Re: *Preliminary Subdivision Plat request for Canterbury Crossing*

Responding to the Preliminary Subdivision Request submitted by Prestige Builder Group for the July 8, 2024 Hudson Planning Commission meeting, we generally agree with many of the comments contained within the Staff Report, with certain initial exceptions:

Before getting into my specific concerns with the proposal, I must raise an objection to the process. Section 1203.10(D) outlines the workflow for subdivision approval: first a Compatibility Review, then a Preliminary Plan Review, and lastly Final Approval.

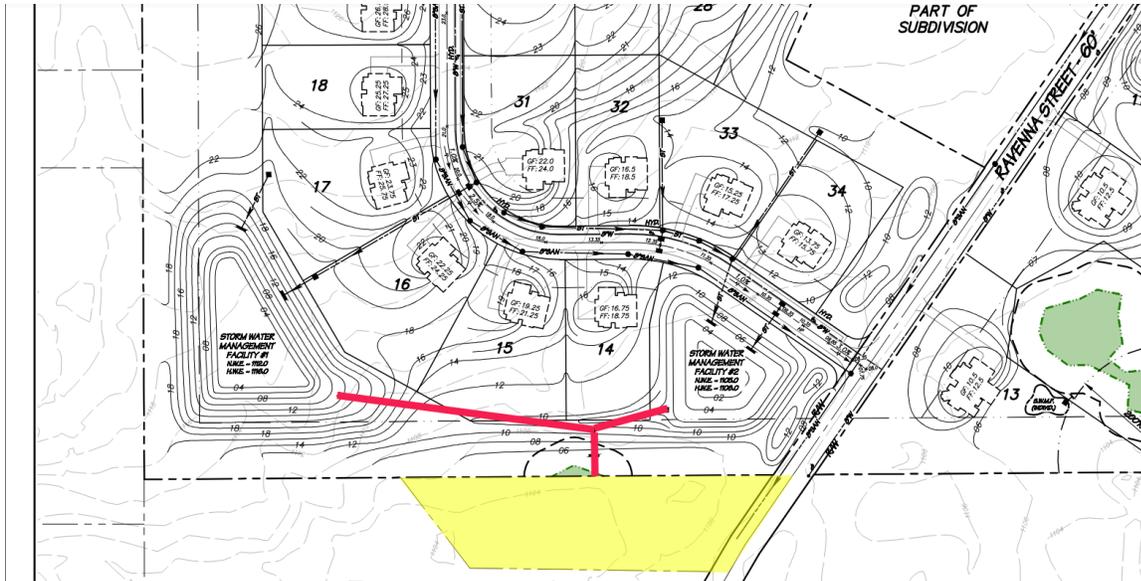
Now, let's discuss stormwater management. If you observe the grading elevations on page 3 of the applicant's site plan (labeled "Utility Plan") you will note that should the ponds ever reach capacity, any water that spills over the banks will travel directly towards my property. This is in direct conflict with Section 1419.05 which requires that major flood paths "... *prevent loss of property or life*".

If you follow the grading lines carefully you will actually find a continuous downward slope from Units 14, 15, 16, 17, 18, 19, 28, 29, 30, 31, 32, 33, and 34 directly towards my dwelling. There is no mounding, no screening, no swales... just lot's of runoff directed at me.

More insultingly, if you zoom all the way to 100%, you will see two pipes leaving Stormwater Management Facility #1 and #2 and converging on my property. The applicant is proposing that you permit them to discharge their stormwater ponds directly onto my property. This is in conflict with Section 660.22 which states that no person shall "... *divert any water or drainage from adjacent lands to or upon any adjacent real property*". I have no agreement with the applicant or the City, and will not permit the discharge of stormwater onto, or through, my property. Who would even maintain the discharges in such a ludicrous proposal - there are no easements.

A city owned stormwater pond is located less than 500 feet west of the project. I propose that adequate mounding should be used on the western border to create both visual screening and a flood swale. Stormwater Management Facilities #1 and #2 should outflow towards Ravenna Street, and then be piped via the right-of-way to the City owned stormwater pond. The City's Engineering Report states almost exactly the same under General Comment (4)(a).

Piping the water will be critical, it cannot be allowed to flow on the surface as the right-of-way has a higher elevation than my front yard and any water discharged at street level will simply flow back towards my dwelling.

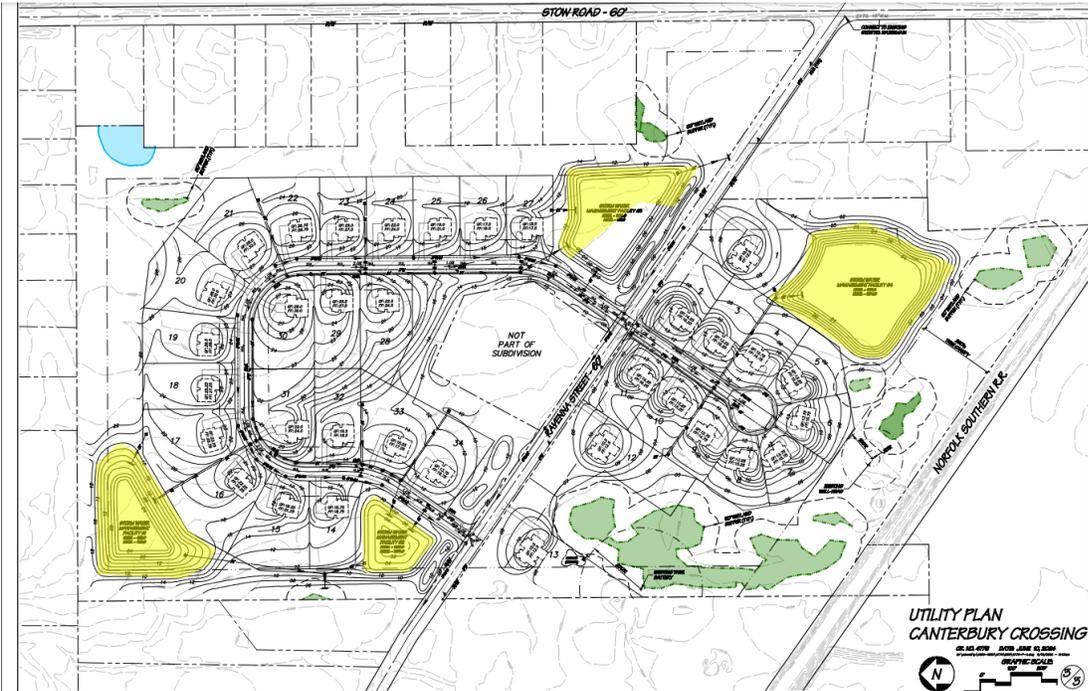
Net density as defined in 1201.07(F)(2) is *".. the measure of dwelling units permitted per acre of land area **contained in the development**, excluding streets, easements, public open space, **land under water**, and certified wetlands and floodplains"*. The 5.61 acres contained in parcels 3002375 and 3006323 are clearly not "contained in the development" as illustrated in yellow on the graphic below. No development activity will take place on either of these parcels. In fact, the applicant even uses a similar argument to explain why 0.48 acres of land on parcel 3001397 is excluded from the project. Shouldn't the same reasoning apply to the entirety of parcels 3002375 and 3006323?

Additionally, the applicant has failed to include new or enlarged stormwater ponds as “land under water”. These new ponds are illustrated in blue on the applicants site plan, and labeled Stormwater Management Facilities #1, #2, #3, and #4. While an exact area was not provided on any drawing that I could find, I think a reasonable estimate is 3 acres on the north, and 2 acres on the south.

Using only the land contained in the development, subtracting the estimated land under water, and using the Rural Residential density of one dwelling per 2.5 acres - you should arrive at 17 units on the north instead of 21, and 11 units on the south, instead of 13. The staff report indicates that public amenities must be incorporated into the final design - which may further reduce the number of allowed units. The detailed math has been provided in Appendix A.
